February 16, 1998

Millstone Nuclear Power Station Unit No. 3  
Response to Notice Request for Information  
On The Recirculation Spray System

MP3 - RSS SYSTEM;  
RESPONSE TO NRC INFORMATION REQUEST  
DATED FEBRUARY 3, 1998

FIGURE 1A

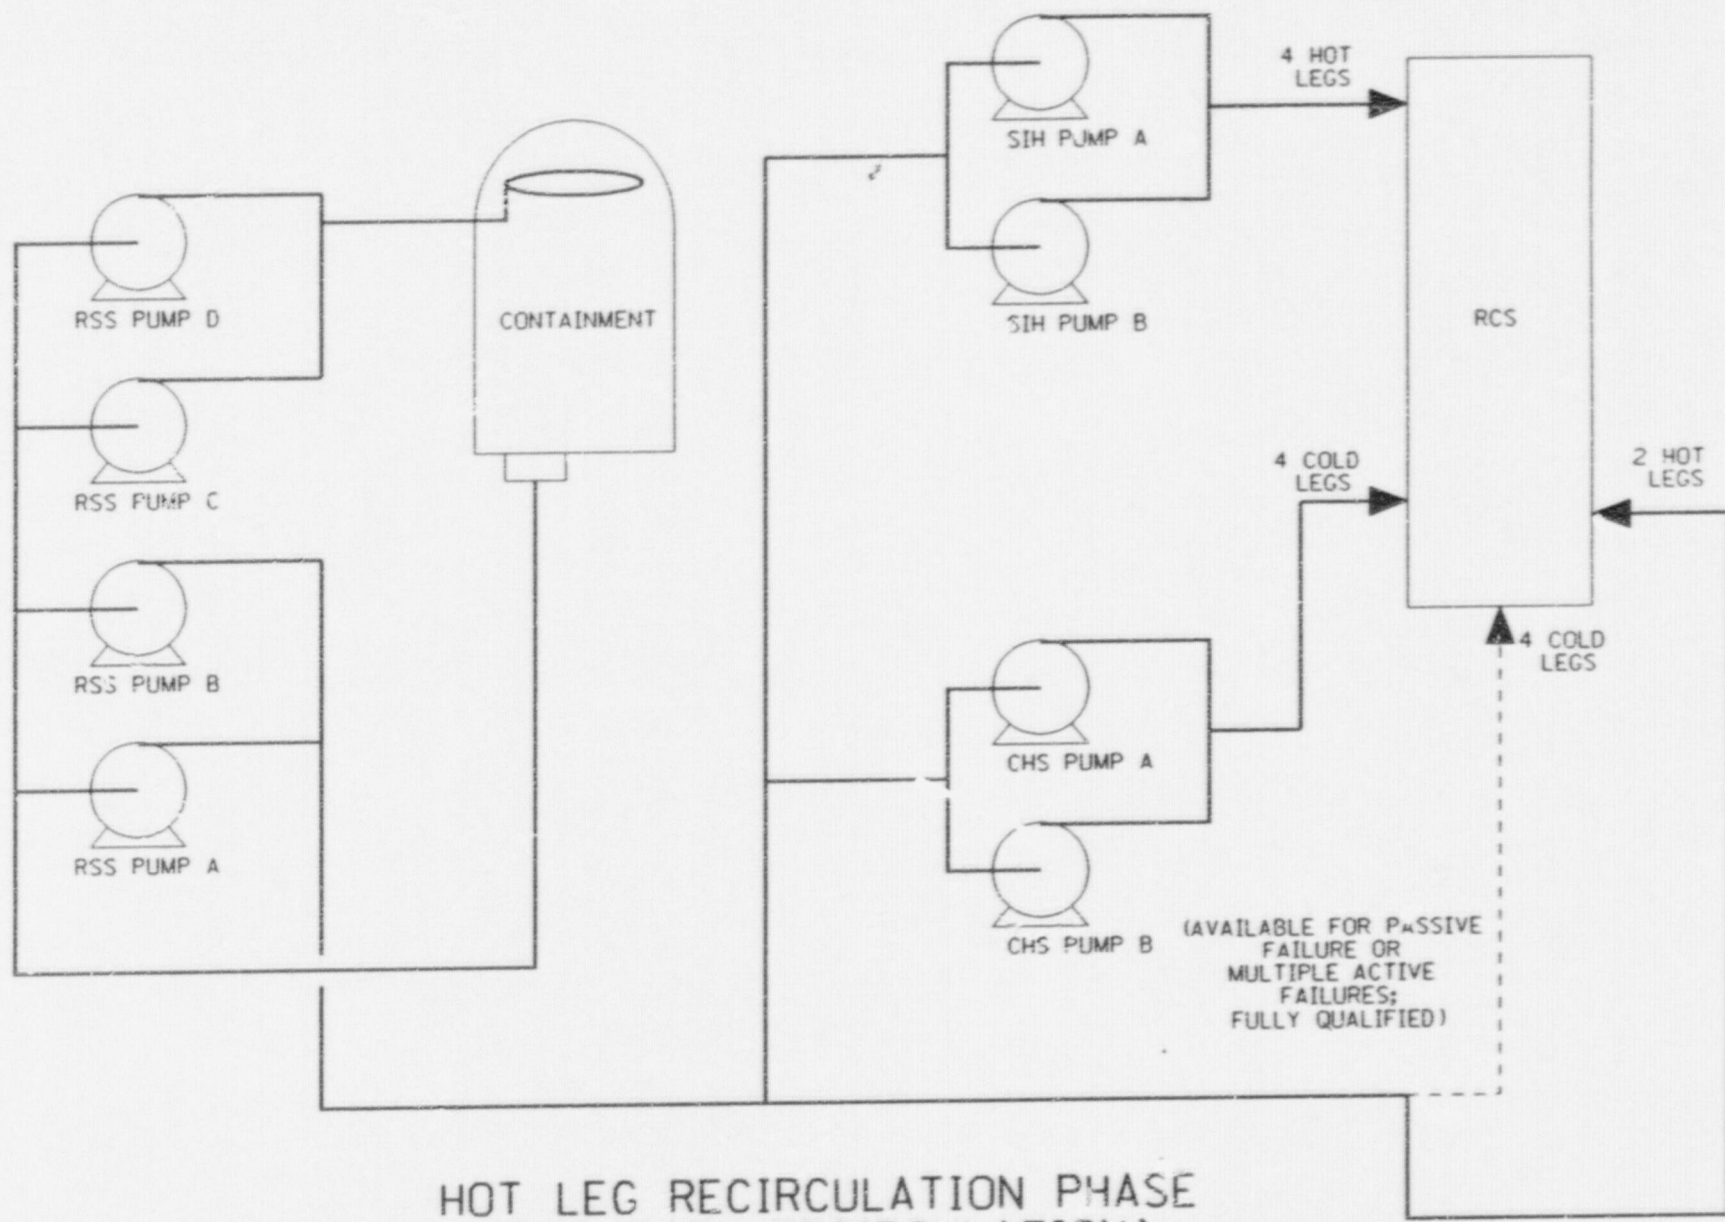
In addition to containment spray, several pathways are available to provide core cooling and makeup through the Emergency Core Cooling System (ECCS) as depicted in Figure 1A. Upon receipt of a safety injection signal (SIS), the following pumps start and align to provide core cooling and makeup from the RWST: one centrifugal charging pump starts, one pump is already in operation, and both pumps inject into the cold legs of all four Reactor Coolant System (RCS) loops. Two intermediate head safety injection (SIH) pumps start. Once the RCS pressure is below the shutoff head of the SIH pumps, they begin to take boric acid water from the RWST and deliver it to the cold legs in all four RCS loops. Two residual heat removal (RHR) pumps start. Once RCS pressure is below the RHR pump shutoff head, they begin to inject into the four RCS cold legs. When the RCS pressure drops below the pressure of the four safety injection accumulator tanks, they discharge their contents into the four RCS cold legs.

FIGURE 1C

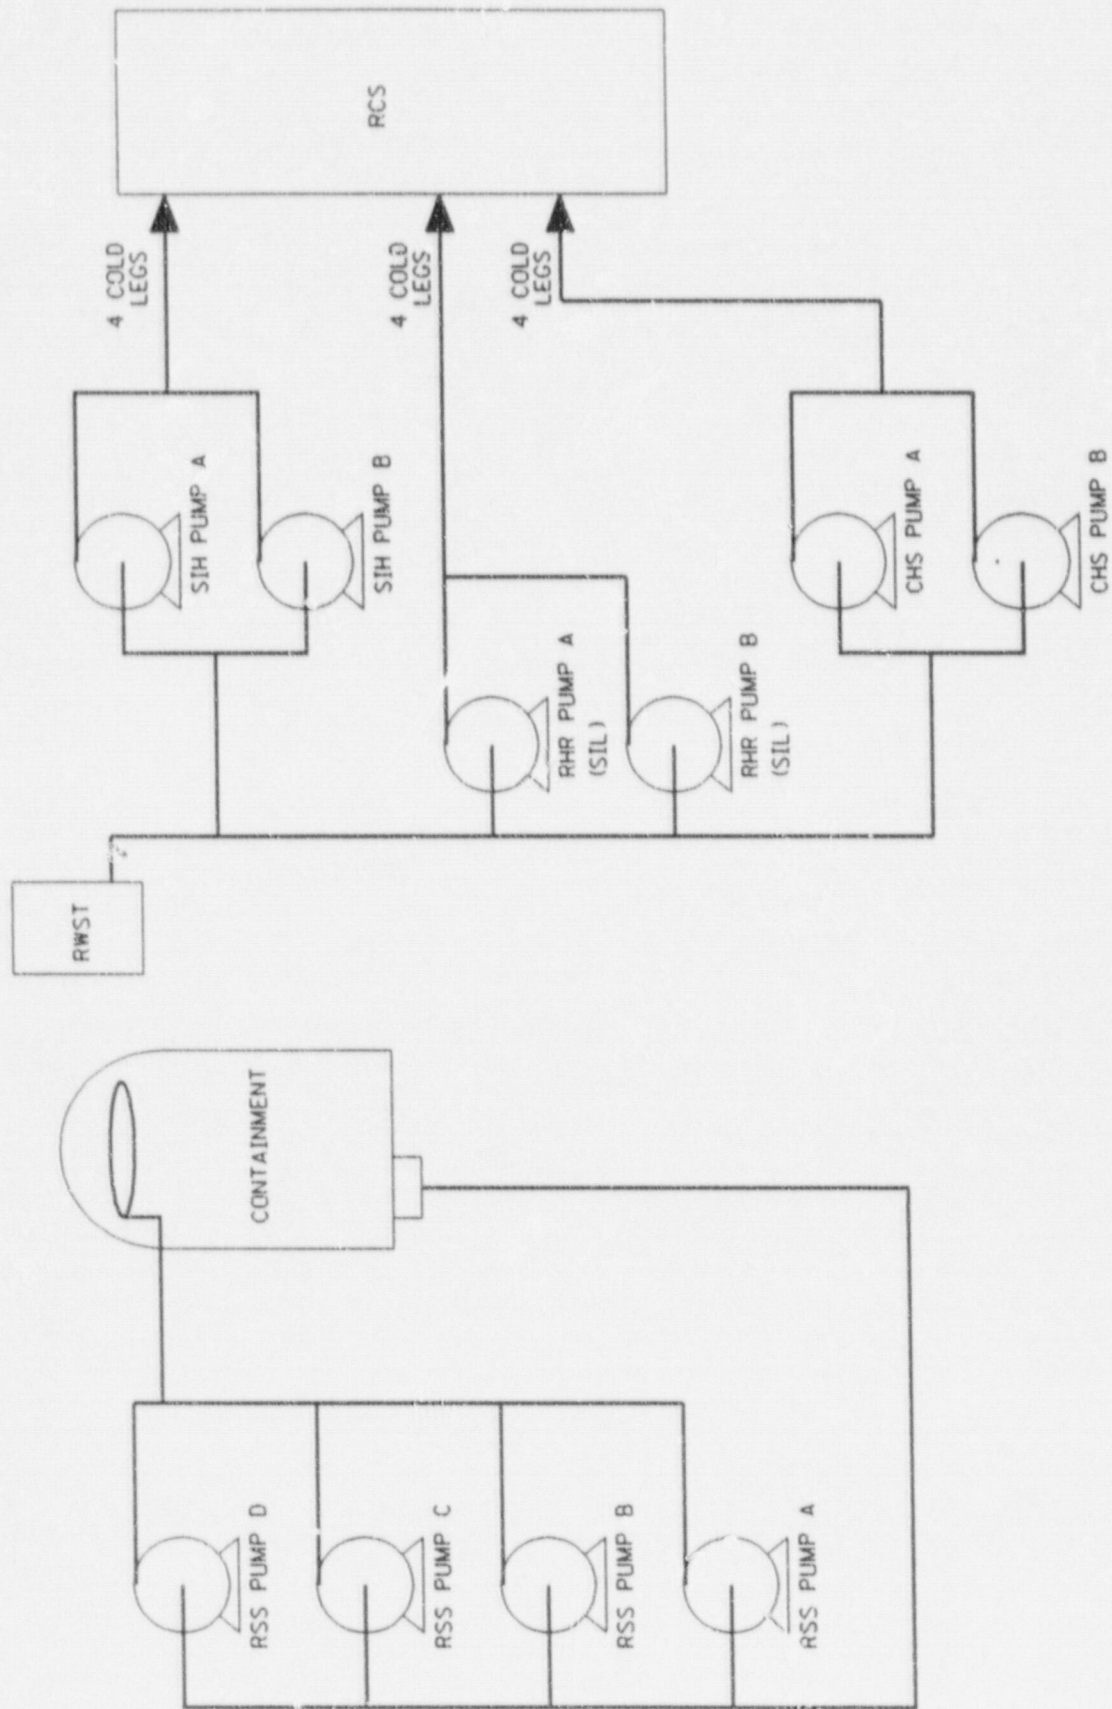
In order to prevent boron precipitation following a LOCA, one additional realignment is performed at nine hours after the initiation of the accident. The SIH pumps are realigned to provide flow to all four RCS hot legs. The RSS pumps are aligned to one hot leg direct injection flow path, supplying flow to Loops 2 and 4. The charging pumps continue to provide flow to the four cold legs, as before. The RSS cold leg direct injection paths are isolated. This alignment is illustrated in Figure 1C.

FIGURE 2B

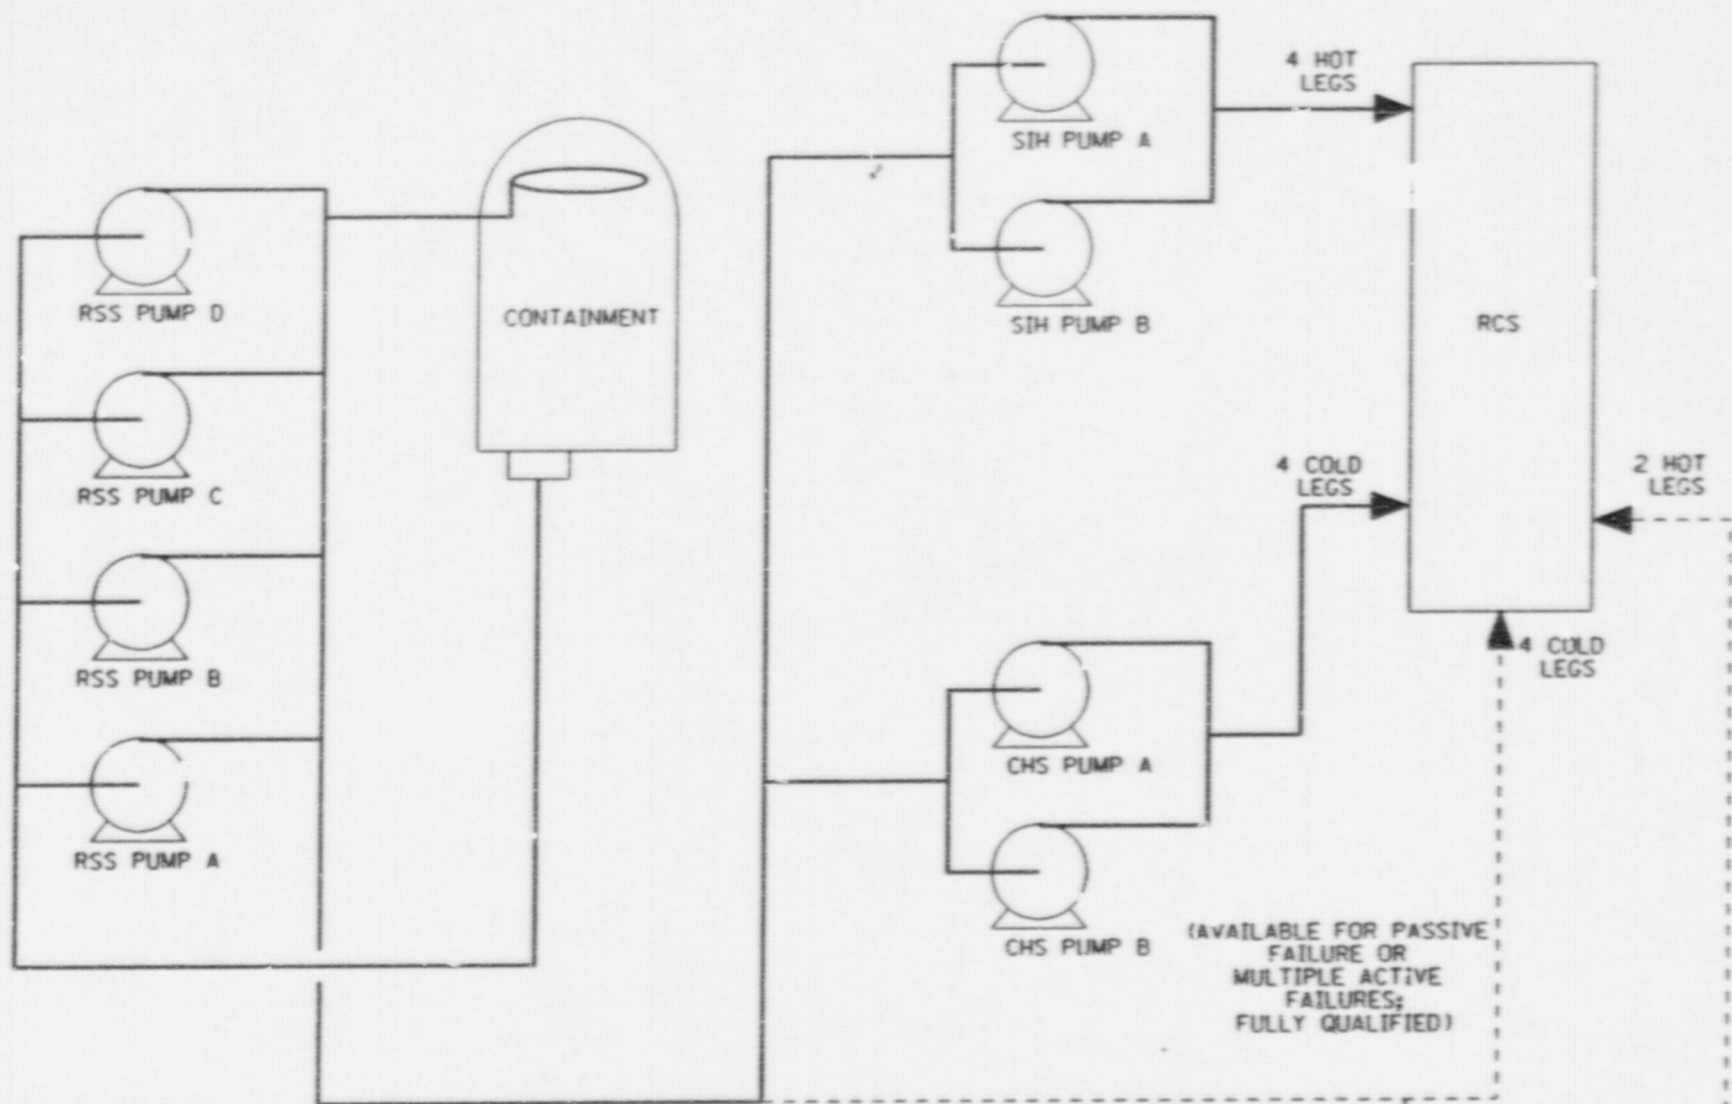
The Cold Leg Recirculation Phase operation of the system in 1998 is similar to the original 1985 alignment with two substantial changes. First, the RSS pumps are not isolated from the containment spray header when they are aligned to supply ECCS cooling. These pumps will provide a dual function: ECCS injection, as well as, containment spray function. Second, the direct injection paths from the RSS pumps to the RCS cold legs are isolated to prevent direct injection to prevent tube vibration. The direct injection flow path remains available as a contingency action in the event that charging and SIH become unavailable. This alignment is depicted in Figure 2B and is controlled by the EOPs.
